DOMINION NUCLEAR CONNECTICUT, INC.
MILLSTONE POWER STATION UNIT 2
SIX-MONTH STATUS REPORT IN RESPONSE TO MARCH 12, 2012 COMMISSION
ORDER MODIFYING LICENSES WITH REGARD TO RELIABLE SPENT FUEL POOL
INSTRUMENTATION (ORDER NUMBER EA-12-051)

**Response to Spent Fuel Pool Level Instrumentation (SFPLI) Requests for
Additional Information (RAIs) and Safety Evaluation Review Item 6**

**Dominion Nuclear Connecticut, Inc. (DNC)
Millstone Power Station Unit 2**

Millstone Power Station Unit 2 SFP Level Instrumentation Plan View

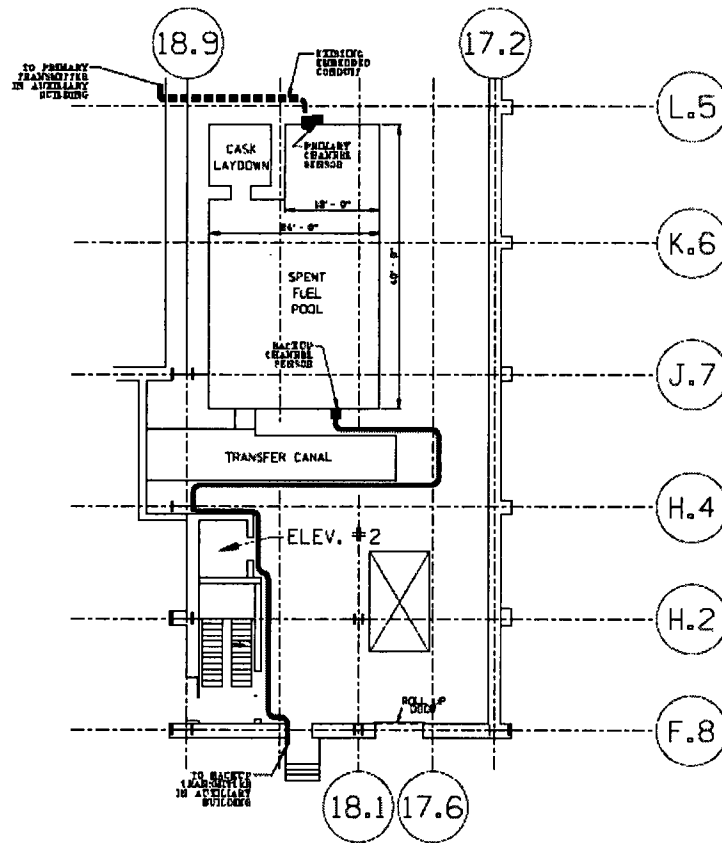
SFPLI RAI No. 1

Please provide a clearly labeled sketch or marked-up plant drawing of the plan view of the SFP area, depicting the SFP inside dimensions, the planned locations/placement of the primary and back-up SFP level sensor, and the proposed routing of the cables that will extend from these sensors toward the location of the read-out/display device.

A plan view sketch of the MPS2 SFP area is provided in the figure below. The sketch depicts the MPS2 SFP inside dimensions, the planned locations/placement of the primary and back-up channel sensors, and the proposed cable routing that extend the sensors toward the location of the electronics.
